# Review Panel Report

## San Joaquin River Valley CalSim II Model Review

CALFED Science Program – California Water and Environment Modeling Forum

**12 January 2006**

**Figure 2. Historical Data and New (Simulated) and Old (OCAP) Model Results for Friant-Kern Canal Diversions (OCAP ends with 1994)**

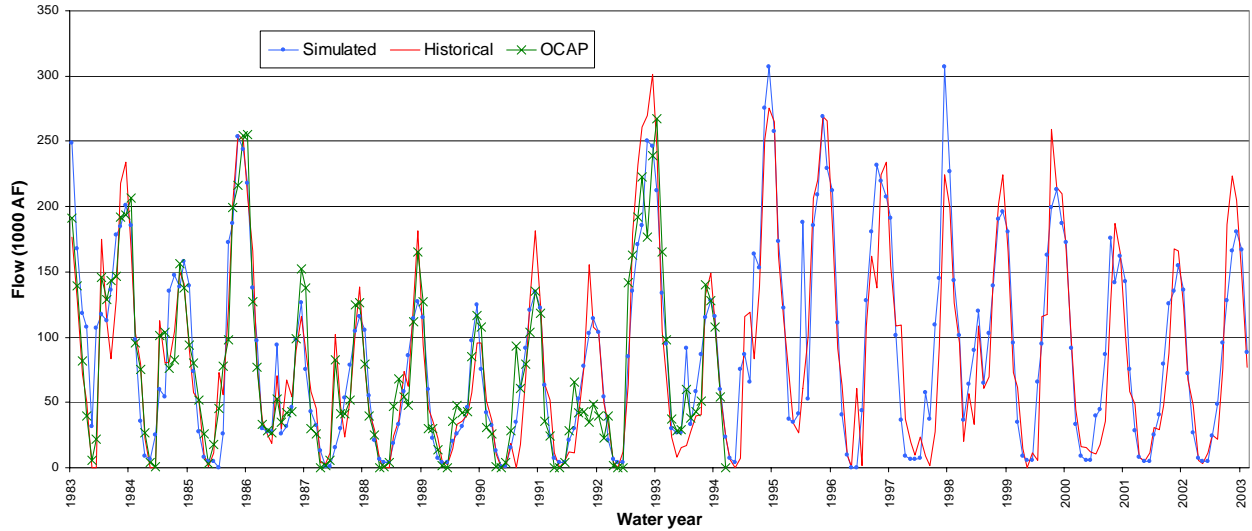
Releases downstream from Friant Dam appear to match those of recent history (not shown here). However, the larger releases from Friant Dam are to the Madera and Friant-Kern diversion canals. These results seem to match fairly well, with model results seeming to under-predict peak diversions a bit in the most recent years, except for some over-predictions in wet years (1995 and 1997), as seen in Friant-Kern Canal diversions, Figure 2.

**Figure 3. Historical Data and New (Simulated) and Old (OCAP) Model Results for New Don Pedro Storage (OCAP ends with 1994)**

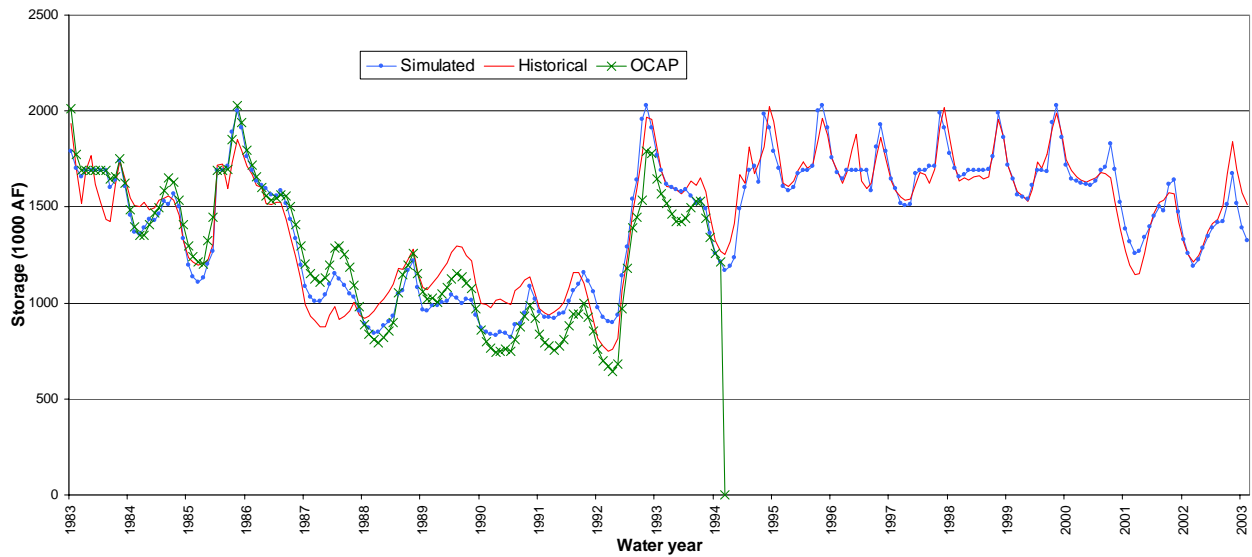
Updated comparison plots, improving on those available in the original documentation, for New Don Pedro storage, releases downstream, and deliveries to Turlock Irrigation District appear below (Figures 3 – 5). These comparisons appear, by visual inspection, to be significantly improved from those available in the original documentation.

**Figure 6. Historical Data and New (Simulated) and Old (OCAP) Model Results for Stanislaus River Flows at Goodwin (OCAP ends with 1994)**

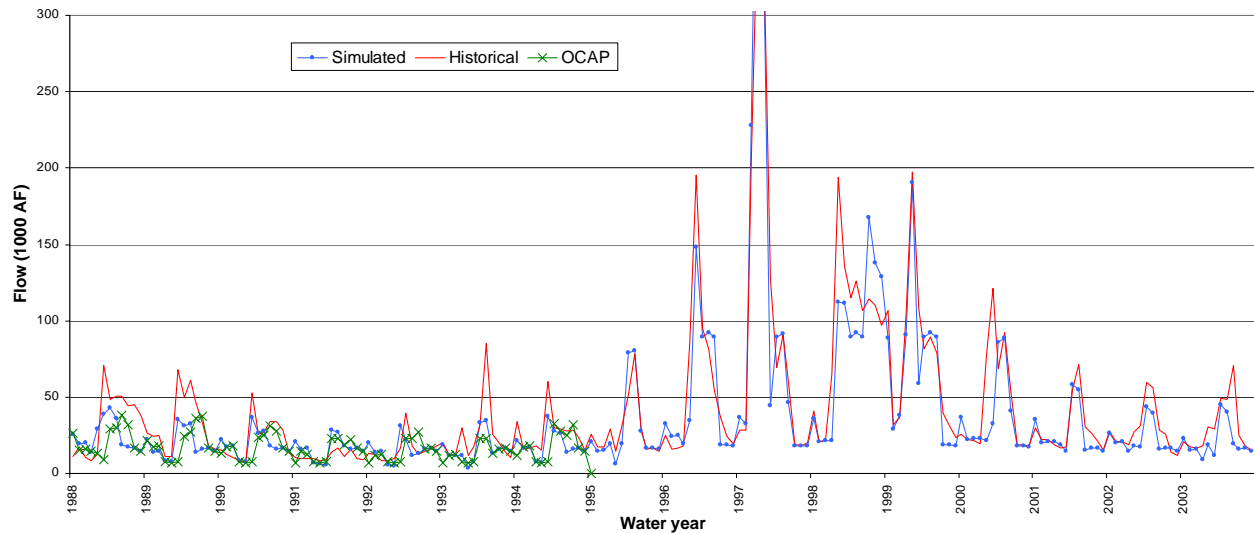
The report (p. 146, Reclamation, 2005) states, “Simulated Stanislaus River operations and diversions track well with historical operations and diversions (see Figure 10-9 and Figure 10-10).). The closeness of the simulation results to the actual recorded operation is somewhat coincidental in recognition of the change in operational objectives that have occurred at New Melones in recent history.” Updated comparison charts appear below in Figures 6 and 7 (Goodwin is downstream of New Melones). Contrary to the statement in the report, looking at the results, there seems to be a pattern of model releases being much lower than historical releases during late winter and spring periods. There is no discussion of this issue in the documentation. The modelers explained orally, after the formal presentations, that there were major changes in CVPIA, VAMP, and new operating rules which make a simple historical

comparison inappropriate for this period. Such important discrepancies should be explained in model documentation.

**Figure 8. Historical Data and New (Simulated) and Old (OCAP) Model Results for Vernalis Flows (OCAP ends with 1994)**

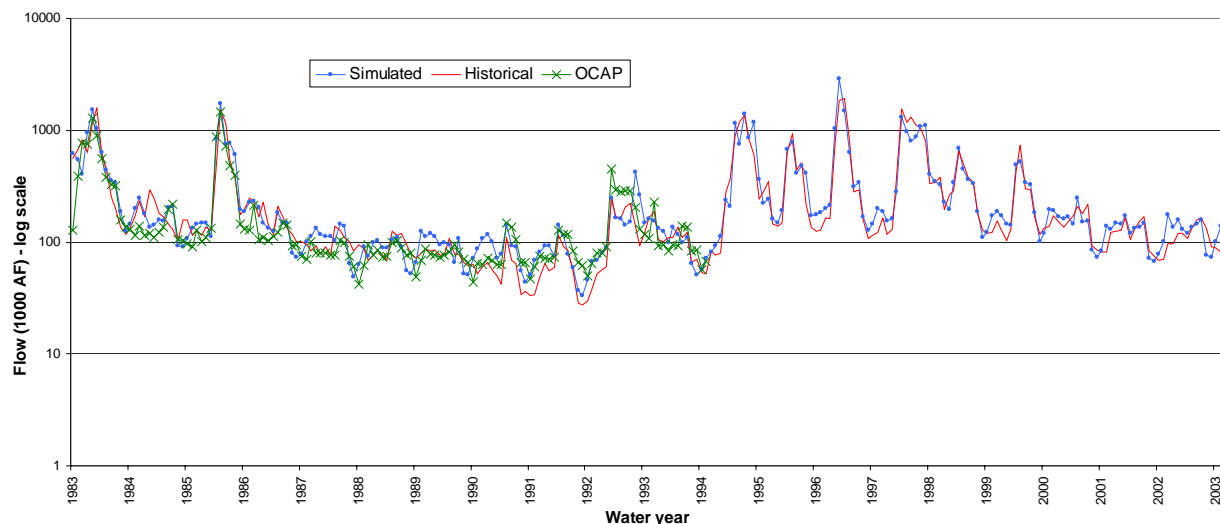
The flow at Vernalis has been used to indicate the “goodness” of CalSim II. The updated comparisons for recent years appear to agree fairly well, even when plotted on a log scale to accentuate differences at low flows (Figure 8).

**Figure 11. Seasonal New Minus Old Model Results for Stanislaus River Flows at Ripon**

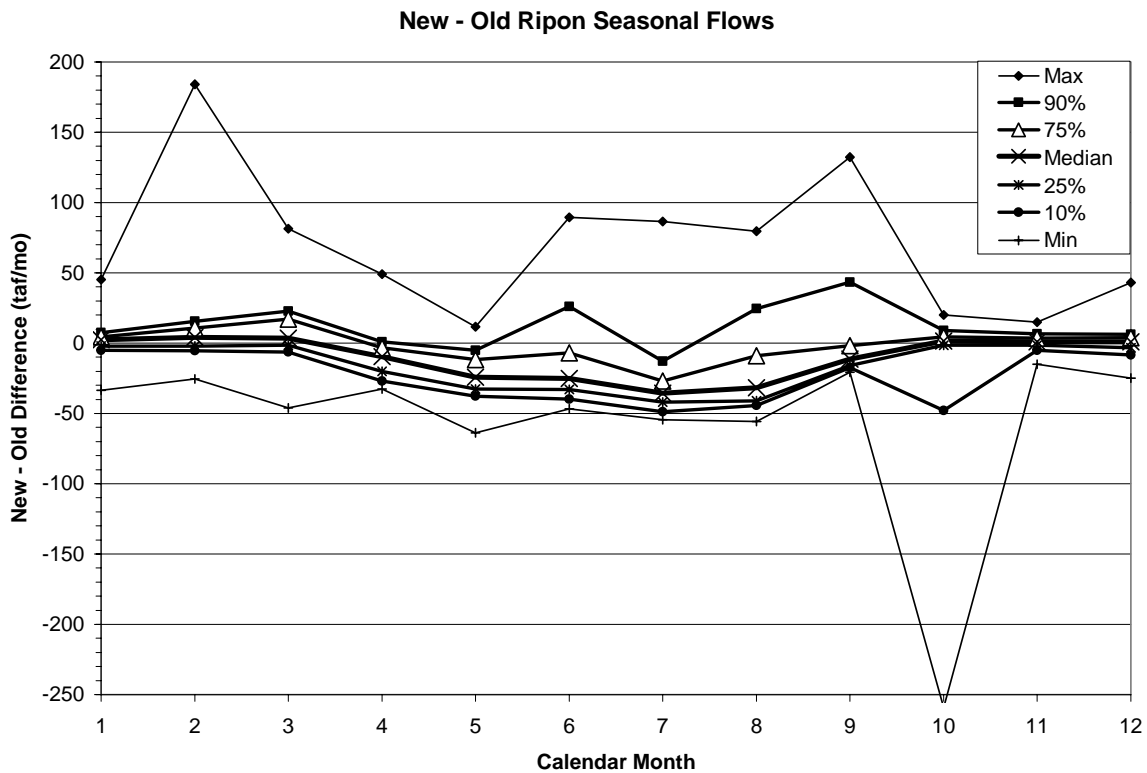
The Vernalis flow comparisons indicate significant differences between the two models, with some pronounced differences for winter months (September through February), Table 2. Flows in the Stanislaus River downstream of New Melones at Ripon also show some differences, tending to be less in May through June, Figure 11.

Figure 12. Seasonal New Minus Old Model Results for Merced ID Deliveries

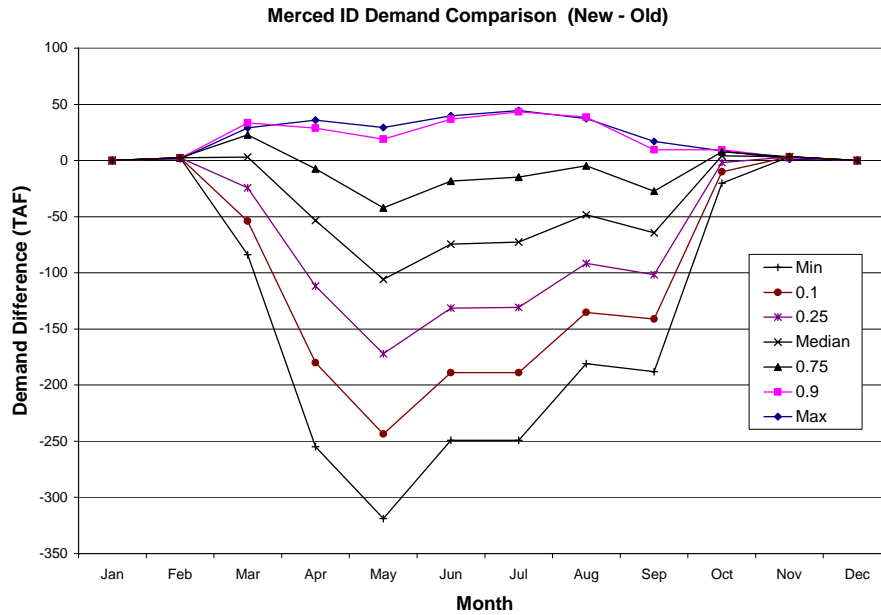
District water demands are lower, as they should be with land-use based demands, rather than contract surface demands, as illustrated below for Merced ID (with corrected data and figures received from Reclamation after August 4, 2005). It would be nice to have data for a direct comparison between older contract demands and newer land-use based demands for all districts. Water demands should now be more variable with hydrologic conditions, as they are in reality, than they were with contract-based demands.

**Figure 14. New (Simulated) and Old (OCAP) Model Results and Historical Data for Maze EC ( $\mu\text{S}/\text{cm}$ ) since 1983 (OCAP ends with 1994)**

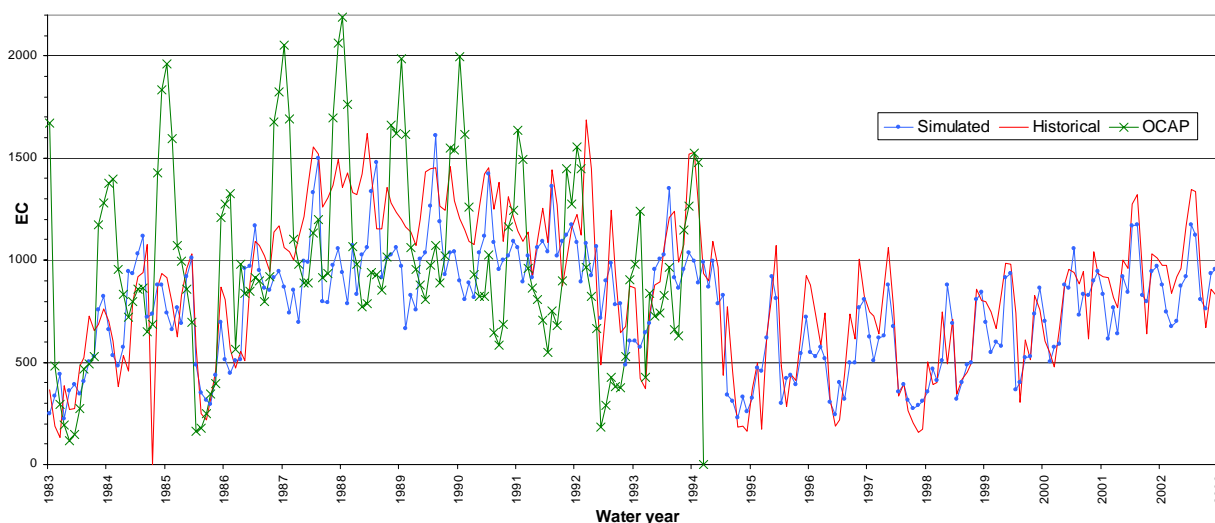
The work done to update the representation of the San Joaquin River portion of CALSIM has clearly succeeded in better representing the physical system with regard to hydrology, operations, and water quality. The model refinement comes with a cost of much greater data needs. In the absence of complete data sets, model developers used various methods and assumptions to calibrate the water quality portion of the model (e.g. use of a load residual regression analysis). Though use of such methods should allow model developers and users to take advantage of the improved representation of the physical system, care must be taken that generated data sets and regression analyses do not contribute to errors similar to those present in the prior representation (e.g. use of a simple flow versus EC regression for Maze). This observation leads to the recommendation that model sensitivity analyses be undertaken to identify critical data needs and that resources be allocated to address those needs. Rather than simply comparing and contrasting the merits of the new representation relative to the prior representation, this discussion focuses on the appropriate use of the new representation, particularly in the absence of sufficient data to independently parameterize more aspects of the model. A comparison plot of old and new model results with historical results appears below.

**Figure 15. Median Monthly Maze EC ( $\mu\text{S}/\text{cm}$ ), 1940-2003 (old model to 1994)**

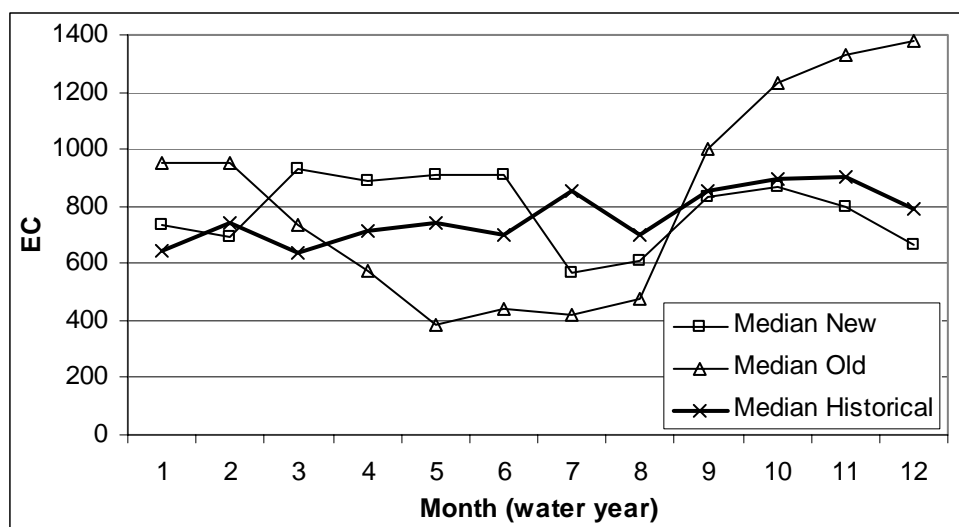
With respect to seasonal shifts, the new representation and assumptions used in the modeled dataset have shifted the time during which EC is elevated in the San Joaquin River (Figure 15). The new representation is expected to consistently calculate lower salinity during the irrigation season and to consistently calculate higher EC during the non-irrigation season than did the prior representation. The large differences in calculated EC are attributable to: 1) use of a different

**Figure B1. Historical minus Calculated Maze Road ( $\mu\text{S}/\text{cm}$ )**

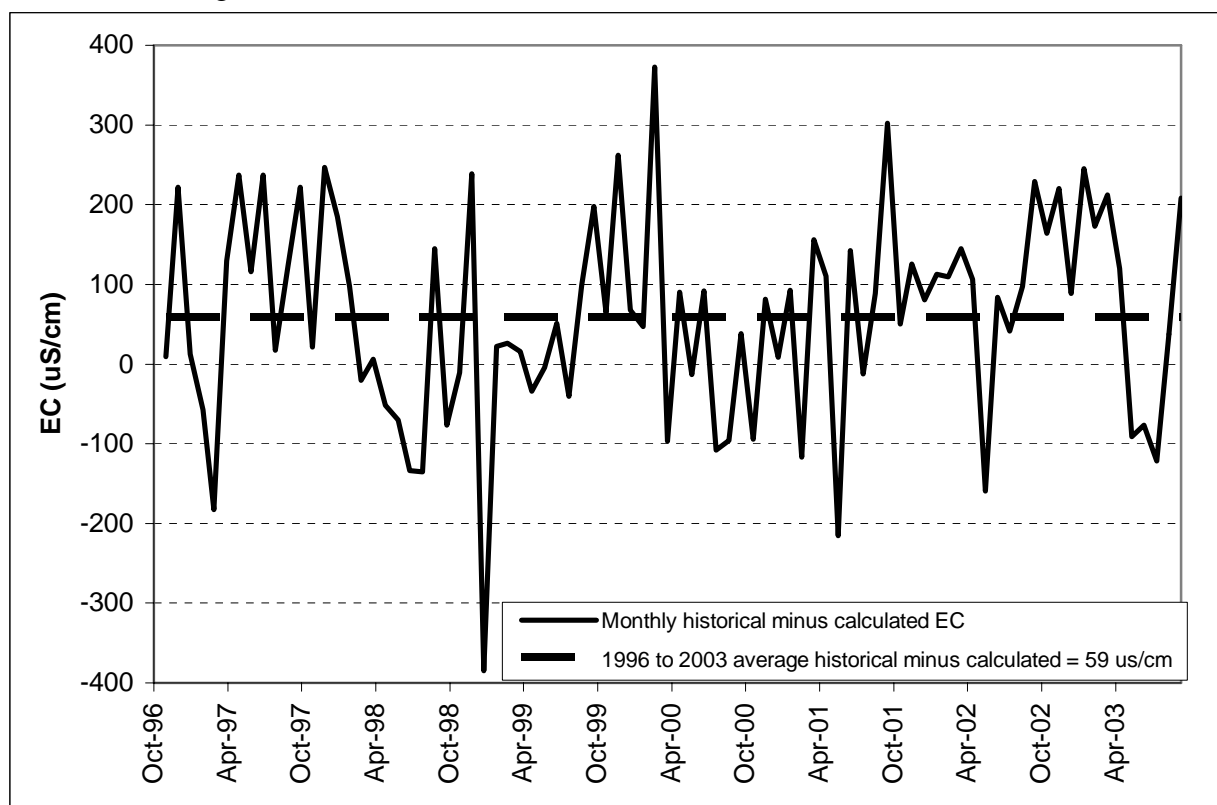
Although EC was calibrated using October 1996 through September 2003 data, calibrated EC is consistently lower than historical EC. Follow-up discussion with model developers clarified that the model was calibrated to match Maze salt loads. Although loads were correctly calibrated, flow was overestimated, resulting in an underestimate of Maze EC. Differences in Maze EC are therefore attributable to overestimates of Maze flow (rather than underestimates of load). Some potential causes and implications of overestimates of Maze flow are presented earlier in the report.

The following example is provided to demonstrate that relatively small errors in EC (or flow) can have not insignificant effects on the calculated need for releases from New Melones.

Monthly differences in Maze Road EC concentration, if applied to CALSIM model calculated flows, can yield a simple monthly excess Maze Road salinity load for all months when the standard is not met (seasonally 700 or 1,000  $\mu\text{S}/\text{cm}$ ). An estimate then can be made of the additional New Melones water that would be needed to dilute this salt load to achieve the salinity standard at Vernalis. We recognize that other factors also control releases from New Melones and that not all of this load would result in the need for additional New Melones releases, but this calculation does demonstrate two things:

**Figure B2. Cumulative positive and negative deviations of new and old CalSim II models from historical data, going backwards from 2003. Old model results (which end in 1994) are begun at the same values as the new model in 1994.**

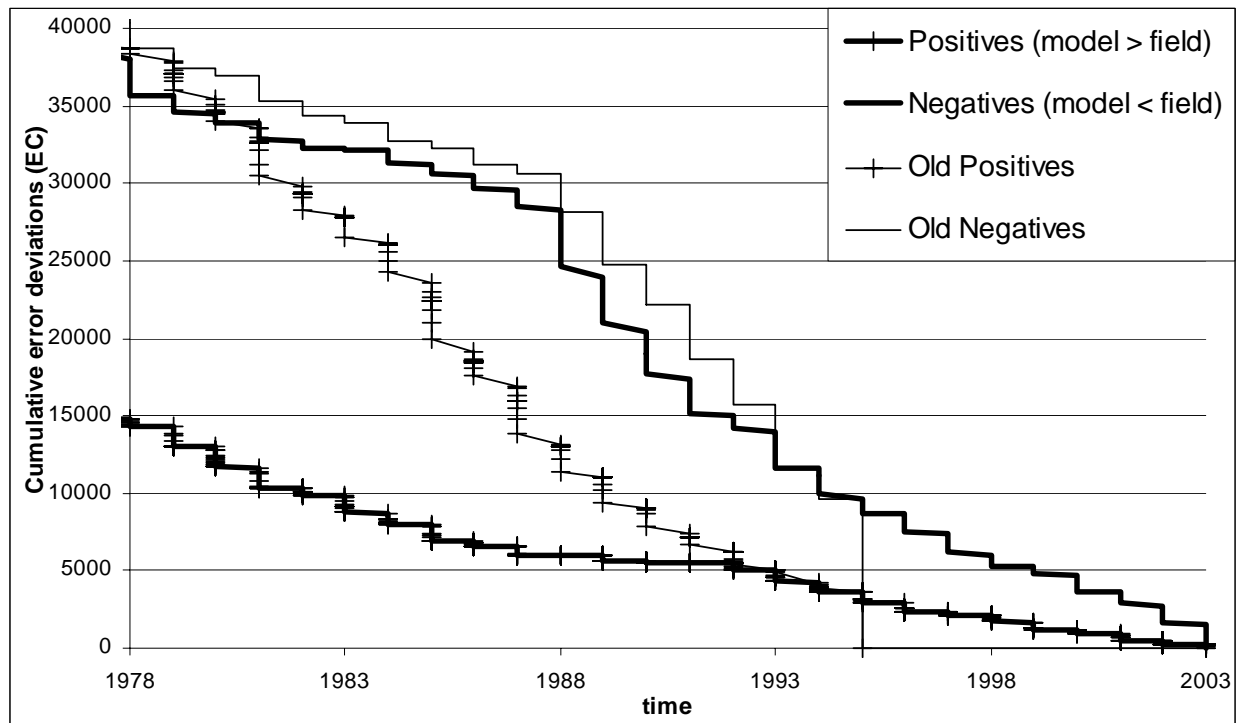
Another view of both the improvement in accuracy and the bias of the old and new CalSim II models appears in the following figure. Here, differences between model and historical EC were cumulatively summed for the new and old CalSim II models, with positive differences (over-predicted Maze EC) separated from negative differences (under-predicted Maze EC). The sums begin in 2003 for the new model. In 1994, old model accumulations are provided, beginning at the 1994 values for the newer model, to improve comparability. Even for recent periods, since 1994, cumulative negatives exceed positives for the new model. Going backwards in time from 1994, both negative and positive errors in Maze EC from the old model accumulate faster than for the new model. This would seem to indicate that, despite the difficulties of making historical comparisons so far back in time, the newer model appears to be more accurate than the older model. However, the reductions in error are much greater for the positives (over-predictions). Perhaps a model's accuracy can increase at the same time as its bias. But this is just an

illustrative example of the complexity of assessing the comparative and absolute accuracy and bias of these models.

**Figure B3. Flow residual averages (instream flow – sum of estimated inflows) at Vernalis**

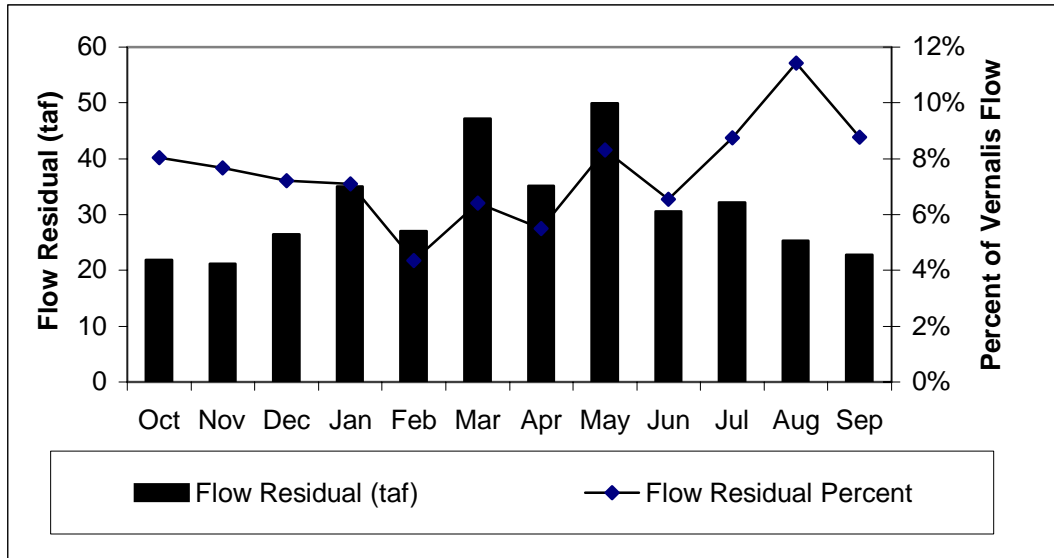
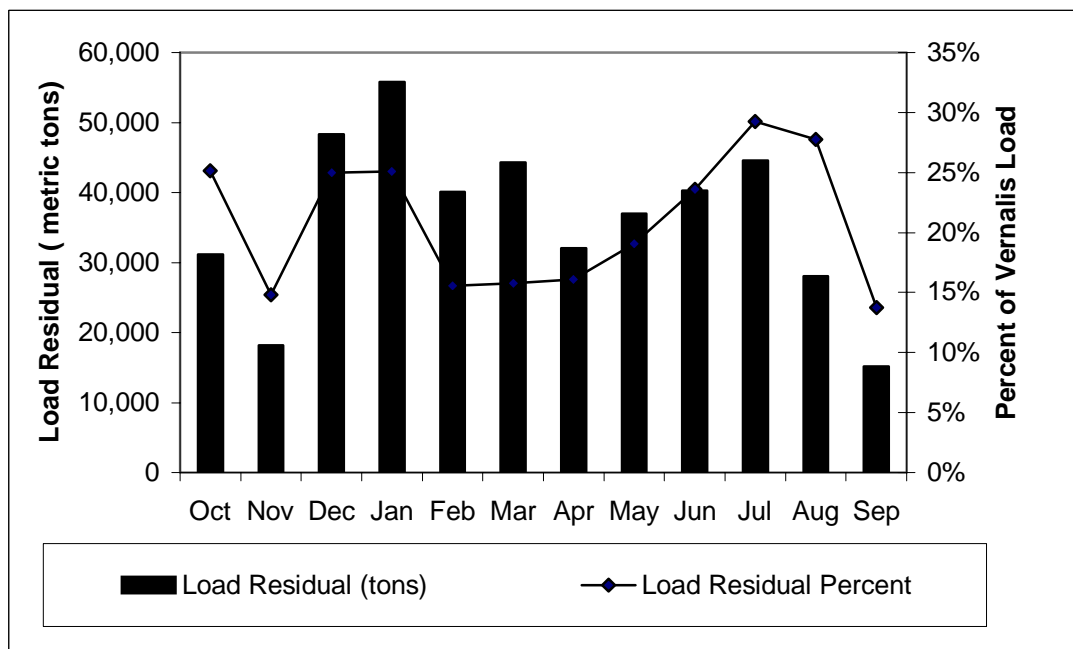
An analysis based on updated load residuals obtained from model developers after the 4 August workshop yielded the following flow and load residuals:

The load residuals are the sum of ‘EC\*FLOW’ units for Local creek inflows I636 (Maze) and I637 (Vernalis). The EC\*FLOW units were converted to tons assuming a TDS/EC ratio of 0.62 so that the load could be compared to total loads at Vernalis. This dataset is similar to the datasets included in Appendix B to the June 2004 Water Quality Module Report (tab 8 in Peer Review Binder). The load residuals in this updated dataset are lower than the residuals contained in the June 2004 report.
